# Historic Preservation Commission Report

**Case Name:** Saltzman Solar  
**Case Number:** 57-HP-2025  
**Location:** 6637 E Coronado Rd  
**Request:** Certificate of Appropriateness to install Tesla solar tiles along with black metal roof tiles on the roof of an existing home located within the Village Grove 1-6 Historic District with Single Family Historic Property (R1-7 HP) zoning.

# Saltzman Solar Site Plan

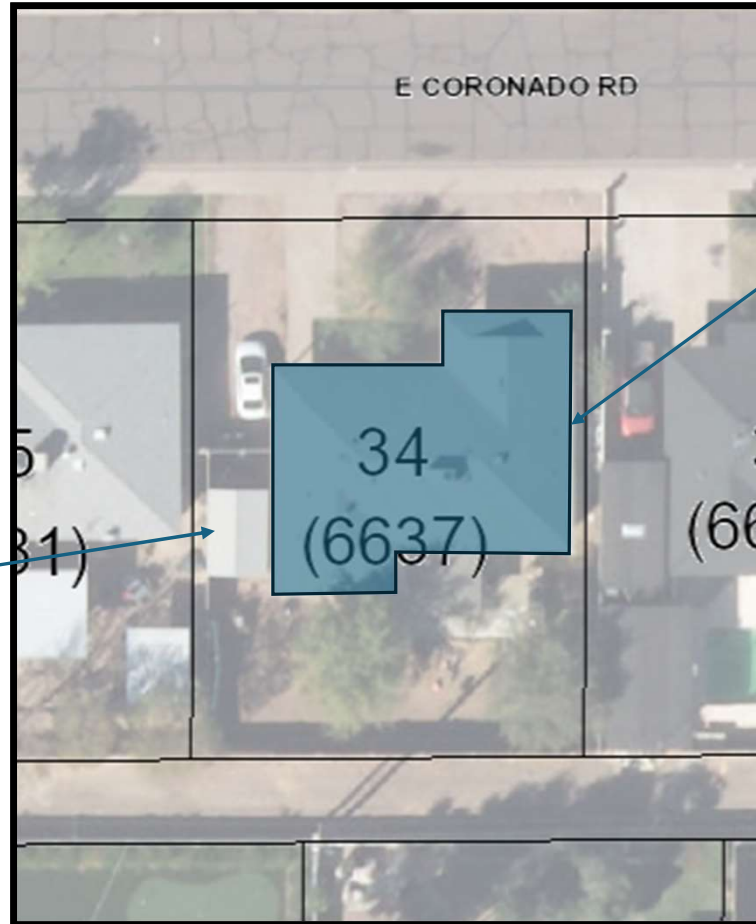
Non-conforming shed to be moved/removed

Area of proposed solar shingles and metal roof tiles

Electrical panel location in the rear of the home and Tesla batteries to be concealed and not located on the front façade

1. In conformance with Village Grove 1-6 Historic Guideline 19.2, the solar and metal roof tiles shall not be located on the front, north, slope of the roof, nor on the front gable dormer above the front door.

2. Asphalt shingles shall be replaced on the front, north, slope of the roof and on the front gable dormer above the front door with an asphalt shingle color to match the new solar tiles and metal tiles on the other sides of the roof.

3. Solar panels may be located on the south, west and east slopes of the roof or an acceptable alternative agreed upon by Historic Preservation staff.
4. Solar tiles shall be low profile and parallel with the plane of the pitched roof.

7. No new sub-panel, batteries or electrical conduit shall be installed on the front façade of the historic property.
8. The Shed within the required side yard, not conforming to the Zoning Ordinance standards, shall be removed or moved to an appropriate location to comply to the required district setbacks.
